## Access Compliance Report Public Rights-of-Way (Curb Ramps)

Intersection ID: 17321 Main Street: QUEENS\_RD\_EAST Cross Street: QUEENS\_RD\_WEST Location: SW

ADA ID: 86C99D26940E Ramp Type: Combination1Diag Initial Pass/Fail: Fail Overall Compliance: No Severity Score: 0

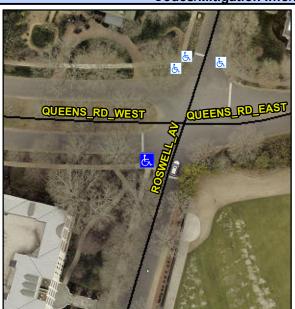
Not Found, R304.3.2, R304.5.3

Remove & Replace Curb Ramp With Two New Directional Ramps or Equivalent.
